| <p><b>MINNESOTA DEPARTMENT OF TRANSPORTATION</b></p> <p><b>DEVELOPED BY:</b> Design Standards</p> <p><b>ISSUED BY:</b> Office of Program Management and Technical Support,<br/>Design Support Section</p> | <p><b>TRANSMITTAL LETTER NO. (14-03)</b></p> <p><b>MANUAL:</b> Standard Plates</p> <p><b>DATED:</b> June 4, 2014</p> |
| <p><b>SUBJECT: Standard Plates 8112, 8117, 8127 and 8128</b></p>  |  |

**Summary of Changes**  
**Standard Plate 8112H – Pedestal Foundation (Traffic Control Signals)**  
**Transmittal Letter No. (14-03)**

STANDARD  
 PLATE  
 NO.  
 8112H

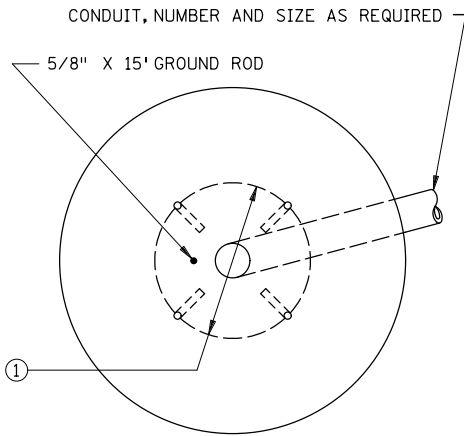
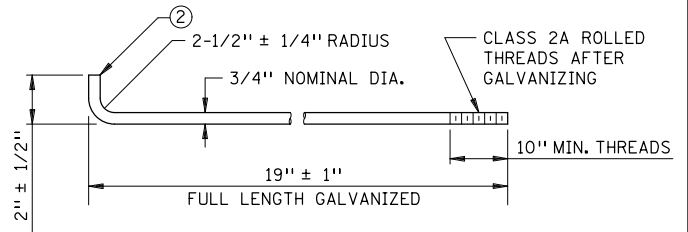
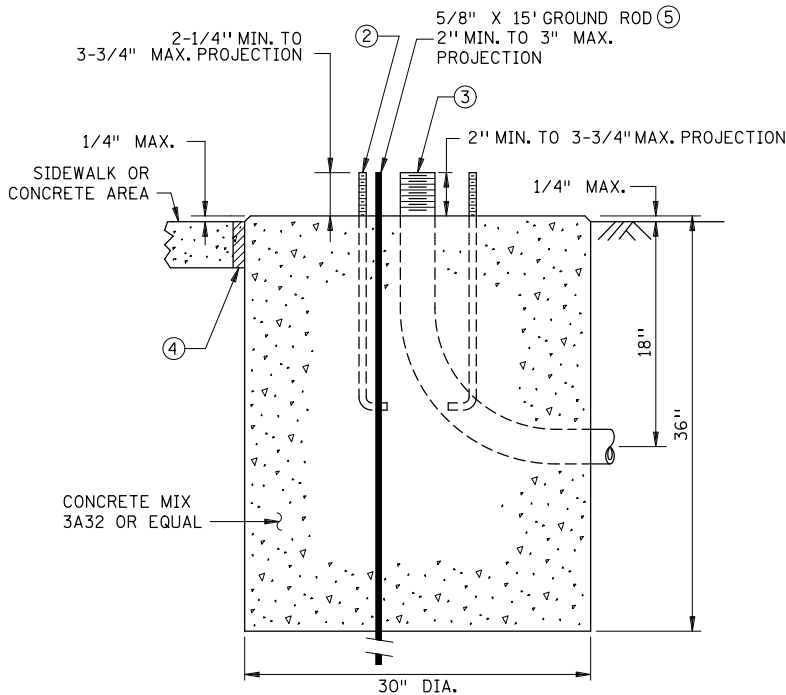
1. Plate number incremented from 8112G to 8112H
2. General note modified from: “A fiber forming tube may be used in forming a round foundation” to: “A fiber forming tube may be used in accordance with 2565.3F..”
3. Note 3 partially modified from: “Conduit per spec. 3801 or 3803.” To: “Rigid steel conduit per spec 3801 or rigid PVC conduit per spec 3803.”
4. Note 2 modified to remove “X 18” MIN.” on the anchor rods.
5. New note added: *End bell fitting on conduit ends shall be included per spec. 2565.3D.*

1. The Contractors Option of a square pedestal was removed from the dimension.
2. Ground Rod dimension added.

1. The square pedestal option was removed.

1. Anchor rod modified to galvanized full length.
  - a. “14” Min. Galvanized” label removed.
  - b. “Full Length Galvanized” label added.

STANDARD  
PLATE  
NO.  
8117G

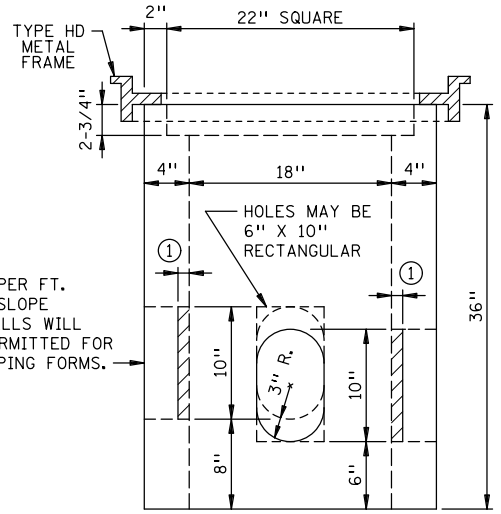
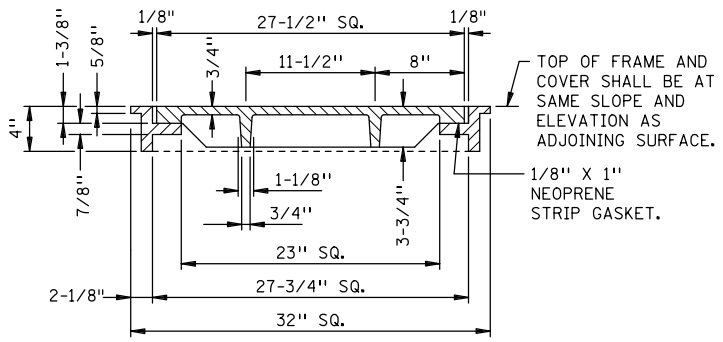
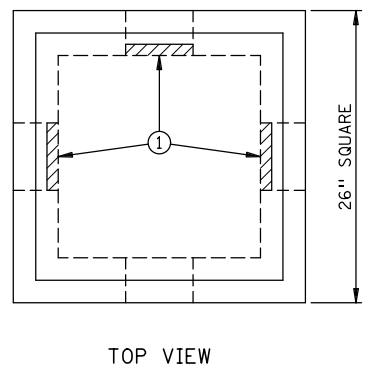
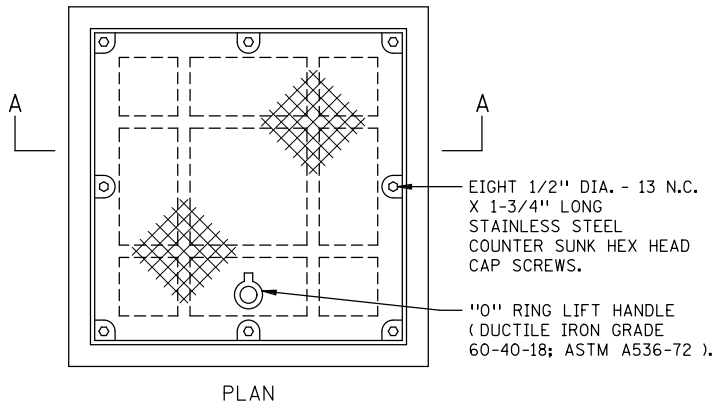
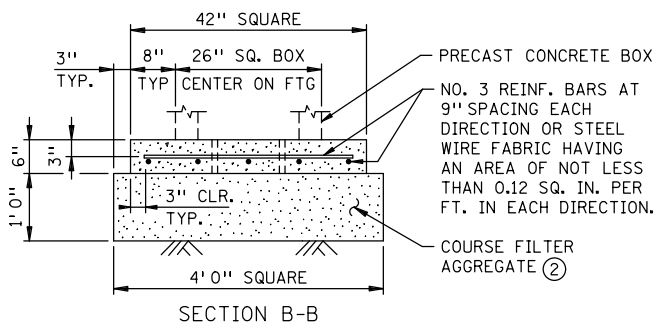
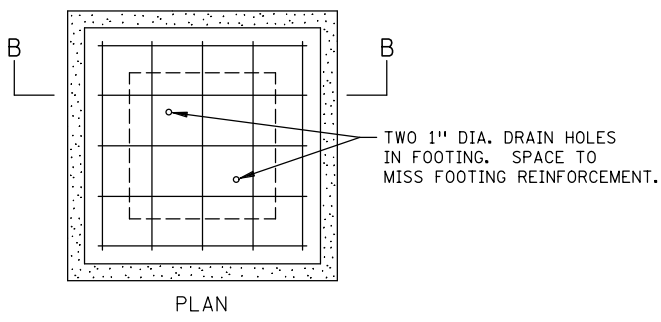
1. Plate 8117F, Sheet 1 of 2, (Precast Concrete Hand Hole (or Pullbox) No Vehicle Load) is removed.
2. Plate 8117F, Sheet 2 of 2, (Precast Concrete Hand Hole (or Pullbox) With Vehicle Load) is renamed to 8117G (Sheet 1 of 1) (Precast Concrete Hand Hole With Vehicle Load)

Note 2 has been modified: *PLACE 4' X 4' X 1' COURSE FILTER AGGREGATE, SPEC. 3149 UNDER FOOTING.*

- The entire assembly shall be listed and labeled in accordance with the latest version of ANSI/SCTE 77 for AASHTO H 20 deliberate vehicular traffic applications.
- Metal frame and cover shall be independently grounded in accordance with the National Electrical Code (NEC) 314.30.
- Excavations and backfilling shall be in accordance with 2451.
- F&I hand hole in accordance with 2565.3E.
- F&I conduits in accordance with 2565.3D.
- F&I end bell fittings on Rigid PVC conduit in accordance with 2565.3D.5b.
- Emboss “MnDOT Signals” on the cover for traffic signal control projects.
- Emboss “MnDOT Lighting” on the cover for roadway lighting projects.
- Emboss “MnDOT TMS” on the cover or ITS projects.

1. Some dimensions modified.

1. Metal Frame added/shown for clarity purposes.

STANDARD  
 PLATE  
 NO.  
**8127D**  
 1 OF 2

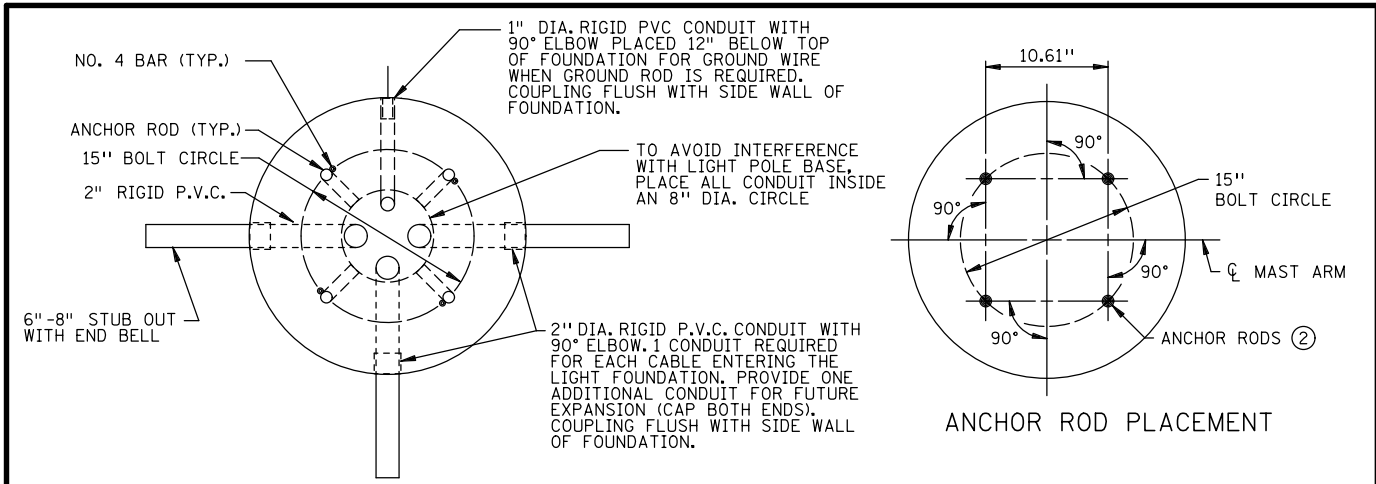
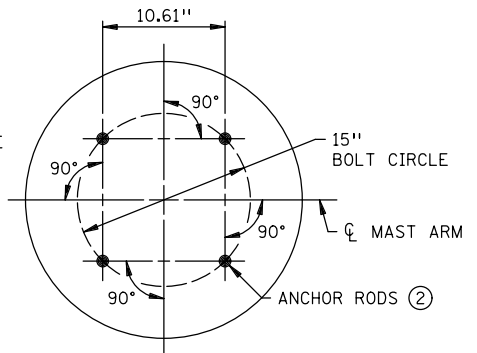
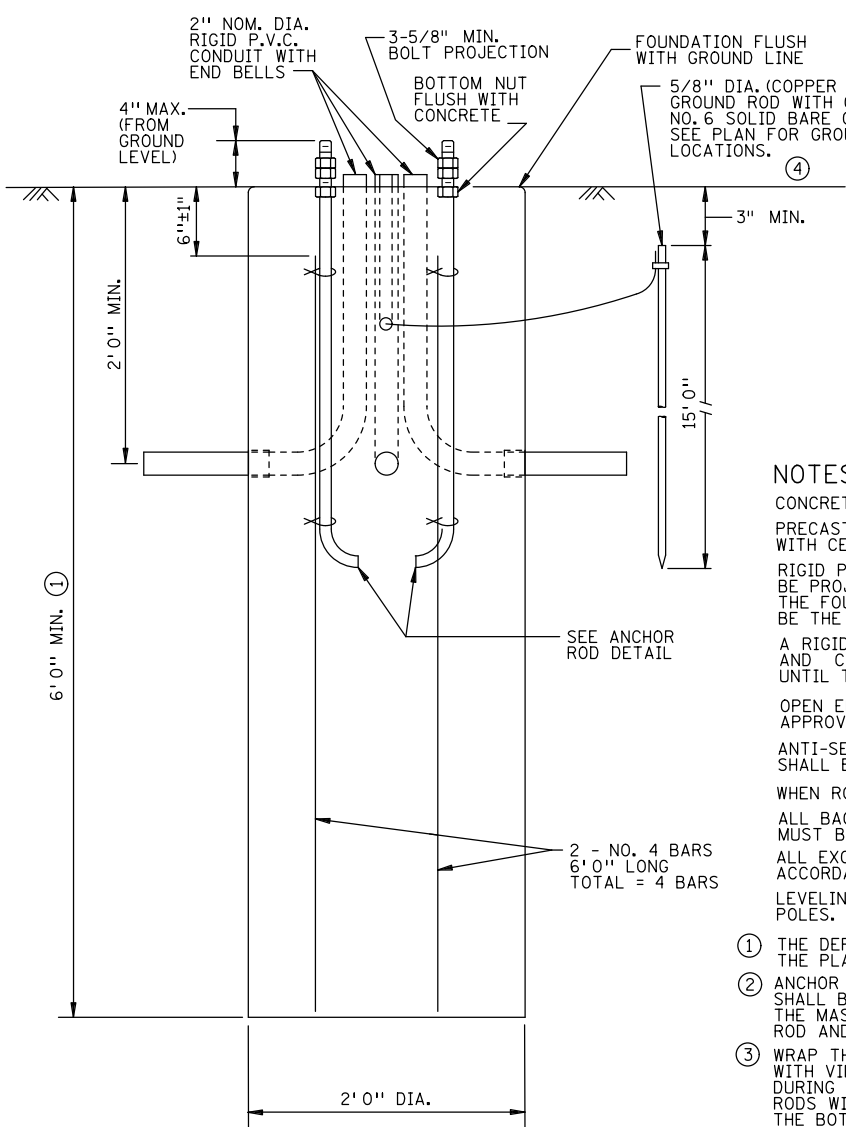
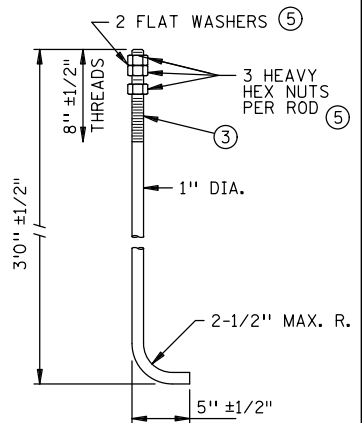
1. New general notes added: “Precast foundation facility must be in compliance with certified plant requirements of Spec. 3238.” and “Open end of conduits shall be sealed with an approved sealing compound”
2. Minor clarification/modifications on other general notes.
3. Note 4 modified to incorporate “below ground line”.

1. Detail clarified to show stub out with end bell, and showing coupling flush with sidewall of foundation.
2. “Light base” language replaced with “light pole base”.

1. Detail clarified to show conduit end bells, stub out with end bells, and showing coupling flush with sidewall of foundation.
2. Ground line modified to be flush with foundation.

1. Note 5 added to clarify washers and heavy hex nuts when aluminum poles are used.

STANDARD  
PLATE  
NO.  
**8127D**  
2 OF 2

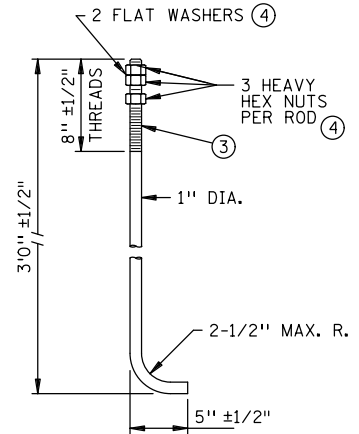
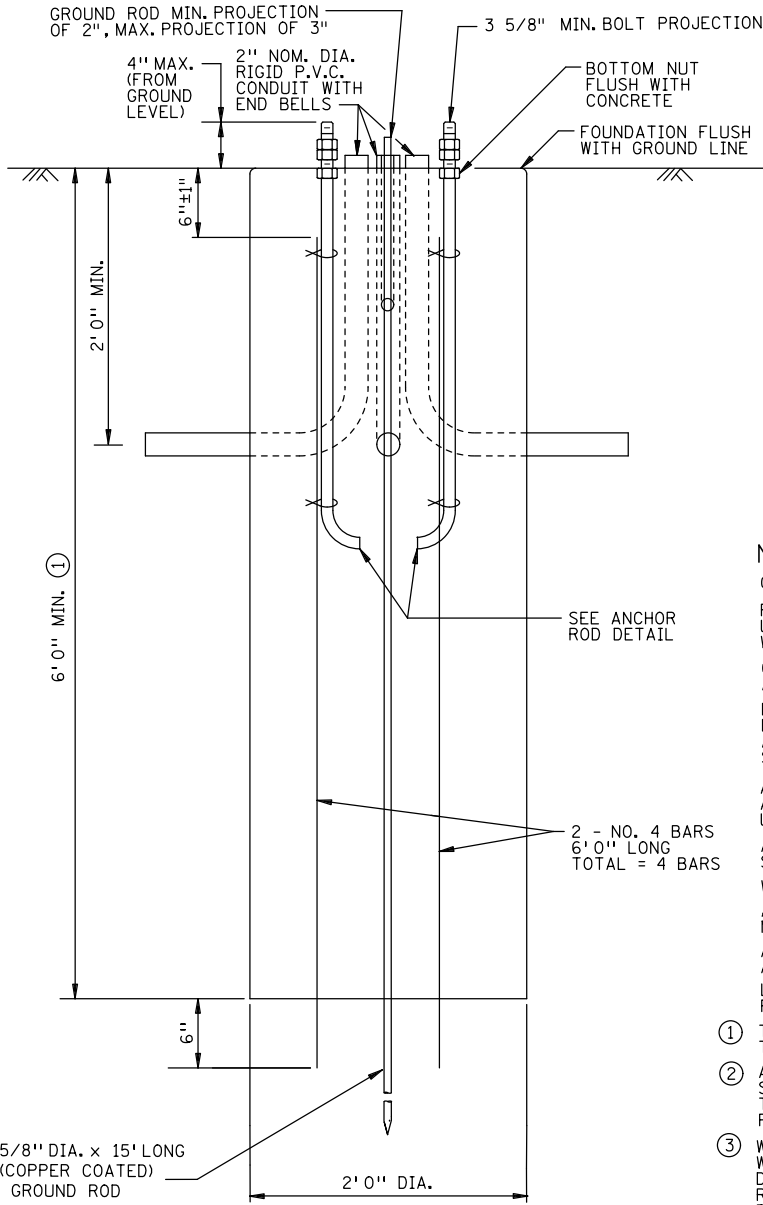
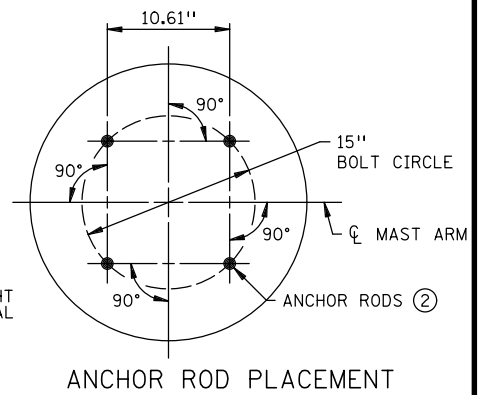
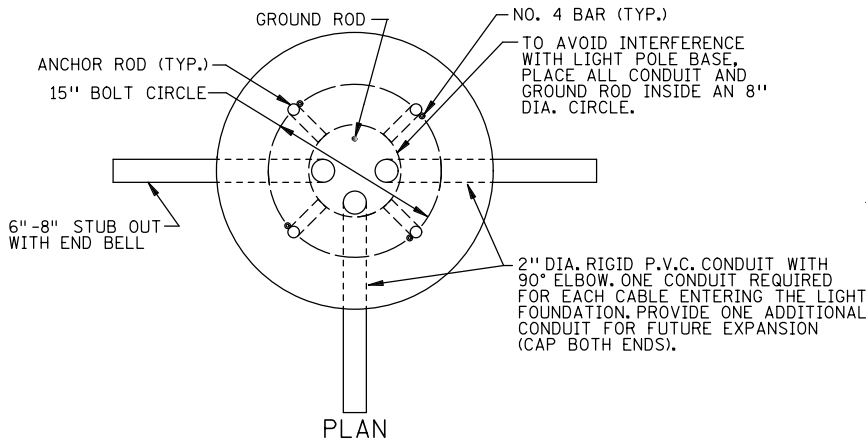
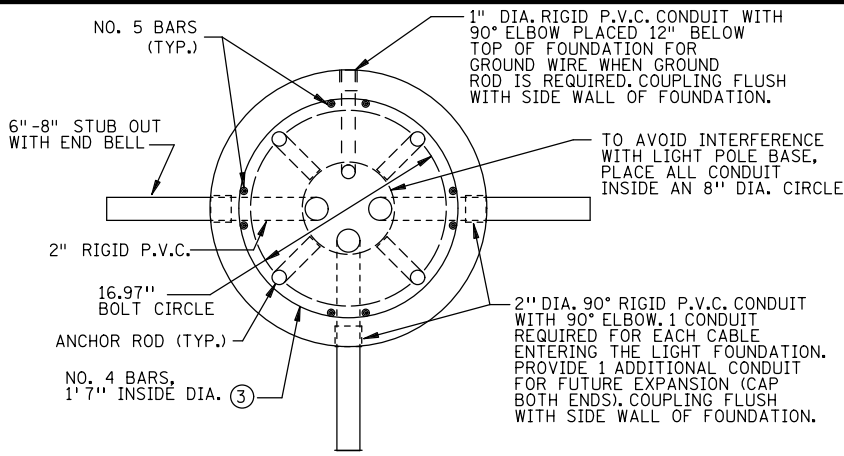
1. New general note added: “Open end of conduits shall be sealed with an approved sealing compound”
2. General note removed: “An alternate precast base manufactured at a facility.....with the Engineers approval.”
3. Minor clarification/modifications on other general notes.

1. “Cast In Place” language removed from detail title.
2. Detail clarified to show end bell.
3. “Light base” language replaced with “light pole base”.

1. Detail clarified to show conduit end bells, and stub out with end bells.
2. Ground line modified to be flush with foundation.

1. Note 4 added to clarify washers and heavy hex nuts when aluminum poles are used.

STANDARD  
 PLATE  
 NO.  
**8128D**  
 1 OF 2

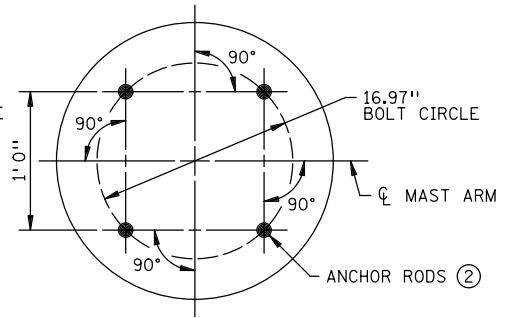
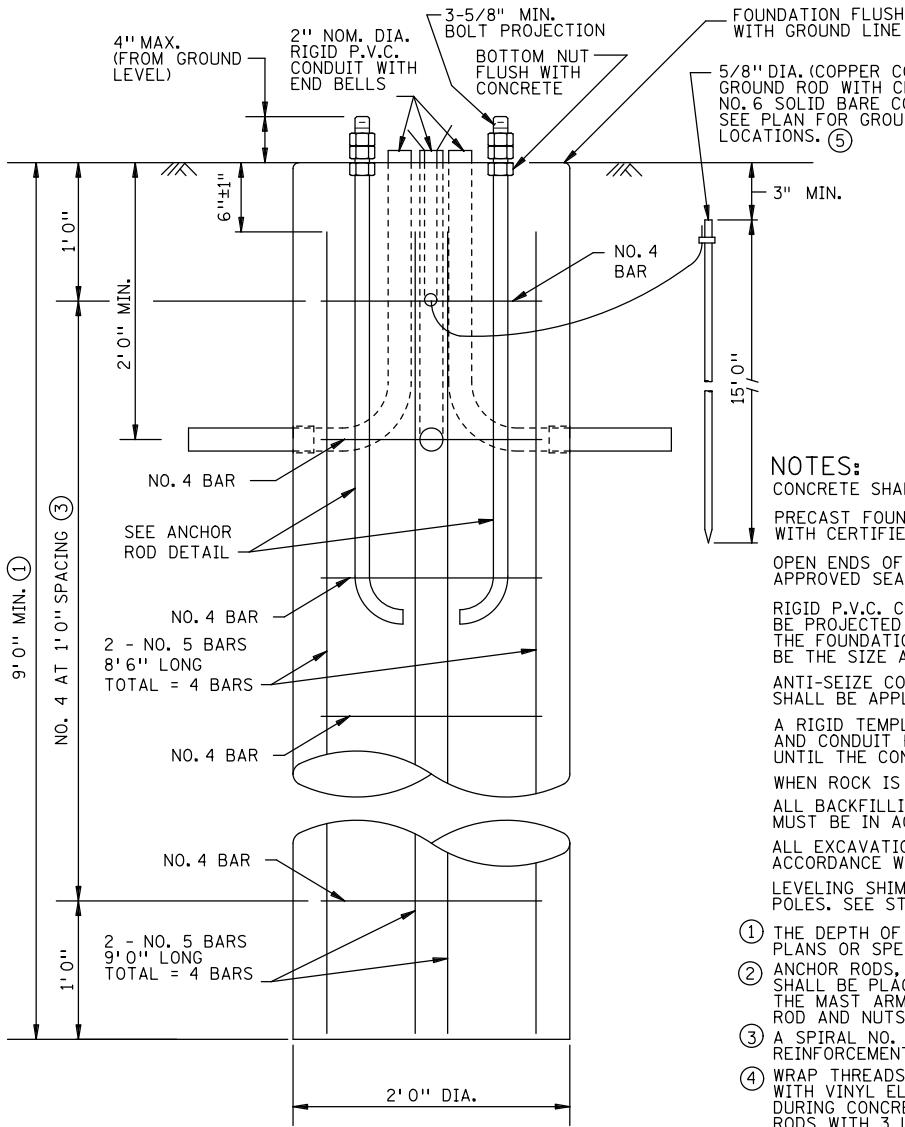
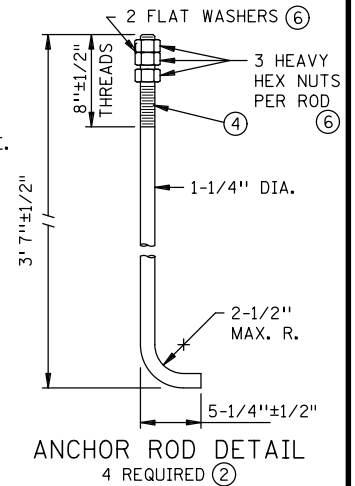
1. New general notes added: “Precast foundation facility must be in compliance with certified plant requirements of Spec. 3238.” and “Open end of conduits shall be sealed with an approved sealing compound”
2. General noted removed: “Foundations may be augured.....forming will be required.”
3. Note 5 modified to incorporate “below ground line”.

1. “Precast” language removed from detail title.
2. Detail clarified to show stub out with end bell, and showing coupling flush with sidewall of foundation.
3. “Light base” language replaced with “light pole base”.

1. Detail clarified to show conduit end bells, stub out with end bells, and showing coupling flush with sidewall of foundation.
2. Ground line modified to be flush with foundation.

1. Note 6 added to clarify washers and heavy hex nuts when aluminum poles are used.

STANDARD  
 PLATE  
 NO.  
**8128D**  
 2 OF 2

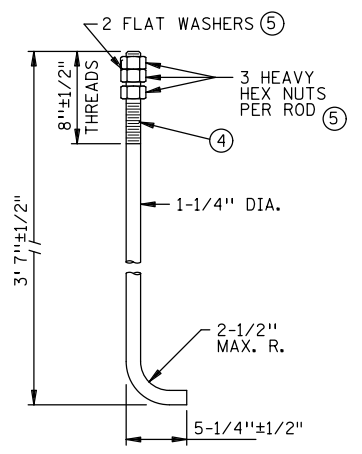
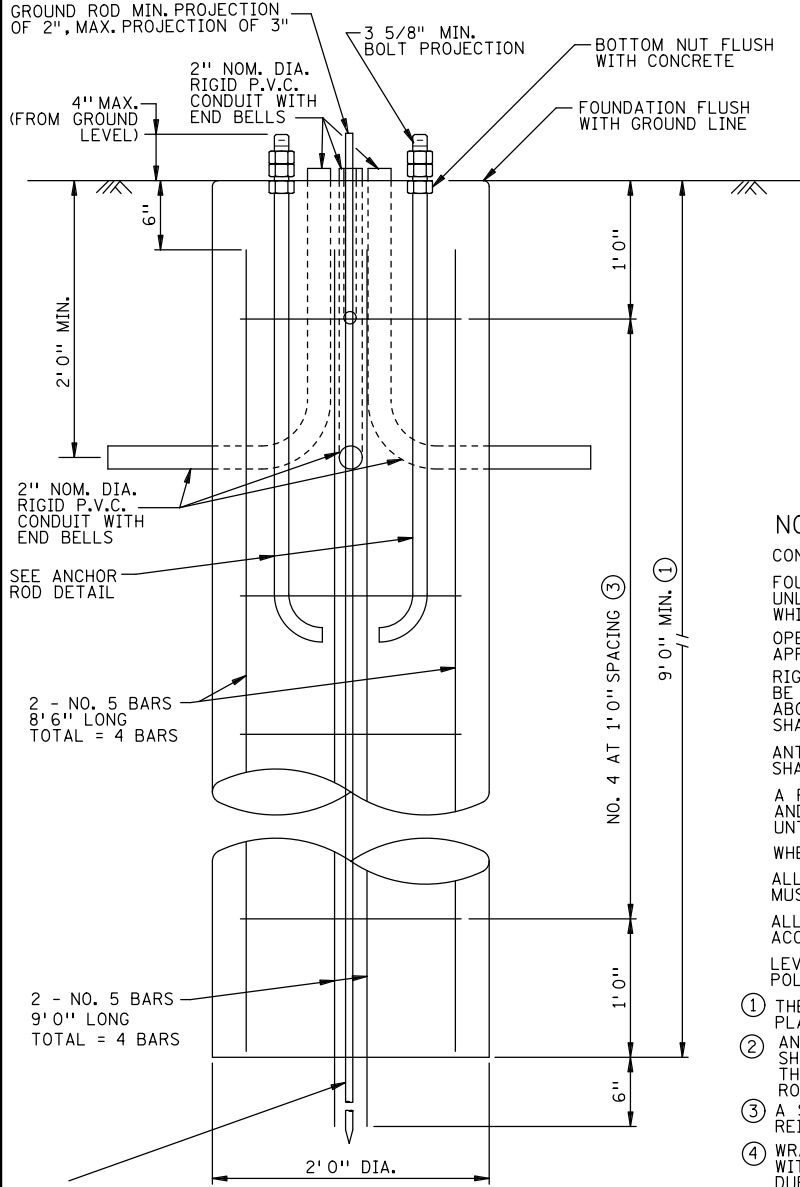
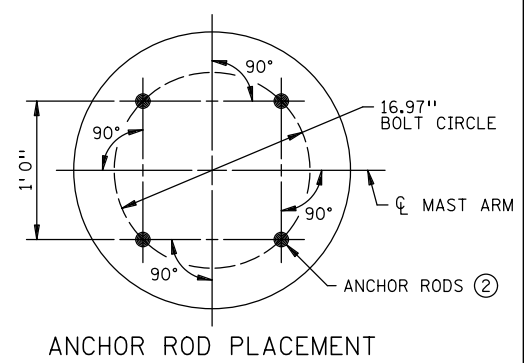
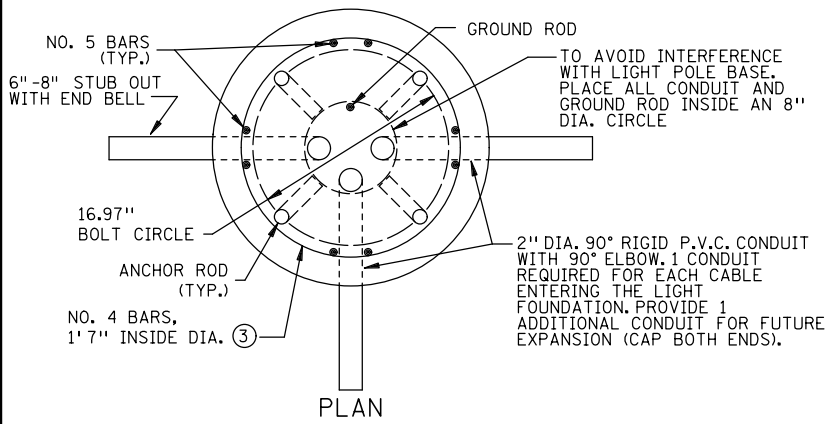
1. New general note added: “Open end of conduits shall be sealed with an approved sealing compound”
2. Minor clarification/modifications on other general notes

1. “Cast In Place” language removed from detail title.
2. Detail clarified to show end bells.
3. “Light base” language replaced with “light pole base”.

1. Ground rod maximum projection dimension modified to 3”.
2. Detail clarified to show conduit end bells, stub out with end bells.
3. Ground line modified to be flush with foundation.

2. Note 5 added to clarify washers and heavy hex nuts when aluminum poles are used.
